Caloosahatchee River Basin Modeling Support – Task 1 Model Evaluations

March 11, 2016

Task 1 Findings

Proposed Revisions

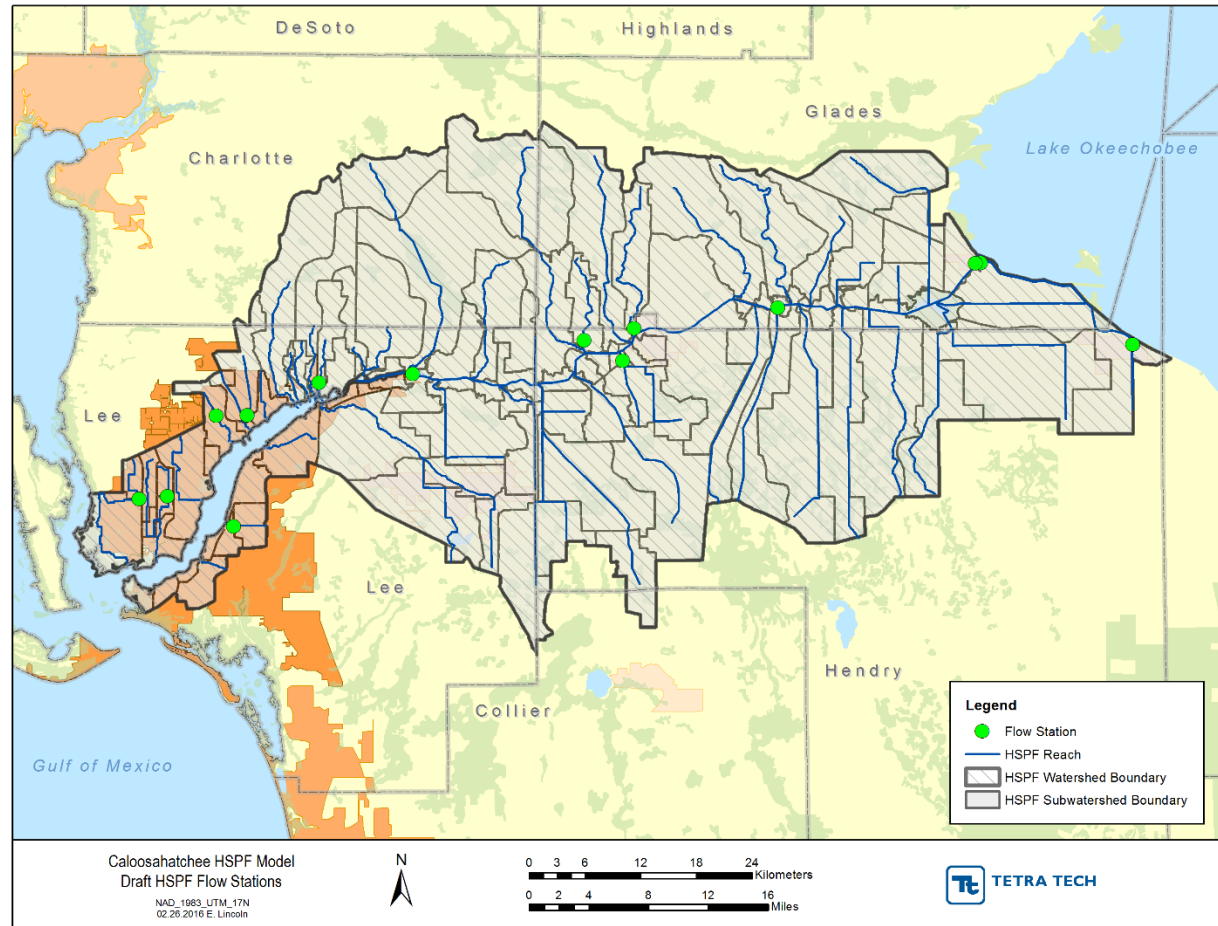
- Issue: HSPF simulation period ends in 2011.
 - Proposed Revision: Extend simulation through the end of 2014.
- Issue: Model watershed delineations and reach segmentation are not correct or adequate.
 - Proposed Revision: Modify the Deep Lagoon Canal watershed based on input from Lee County.
 - Proposed Revision: Delineate subbasins to flow and water quality calibration stations.
- Issue: Priority reaches with bidirectional flow.
 - Proposed Revision: Overlay simplistic EFDC model grid over critical HSPF model reaches upstream of S-77.
 - Proposed Revision: Extend current Caloosahatchee EFDC model grid to capture the bidirectional flows in priority reaches downstream of S-77.
 - Cape Coral canals, Billy's Creek, Orange River, and Yellow Creek.

EFDC General Overview

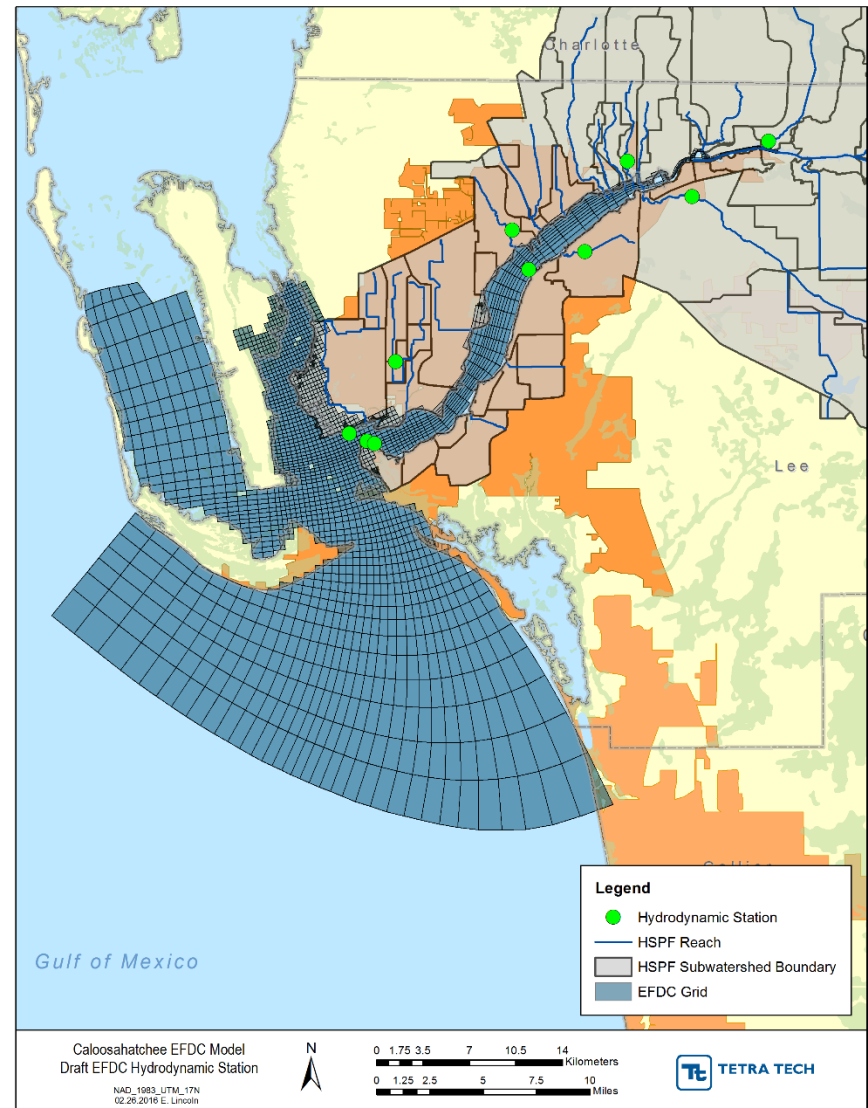
- The grid has a good spatial representation of the harbor and estuary areas.
- The current model is based on Dynamic Solutions' proprietary code.
- The grid includes boundary tidal cells for both the main waterbody and shallow marsh areas, which is causing some model instability.
- Some of the deep water model cells are not well connected to the channels, which could be causing issues with representing the salinity wedge.
- The marsh areas in model are much deeper than the depths indicated on the NOAA nautical charts.
- The 2009 and 2014 EFDC models are linked to the HSPF model and all the linkages seem to be correct.
- The water quality parameters are within expected normal ranges for southeastern estuaries.
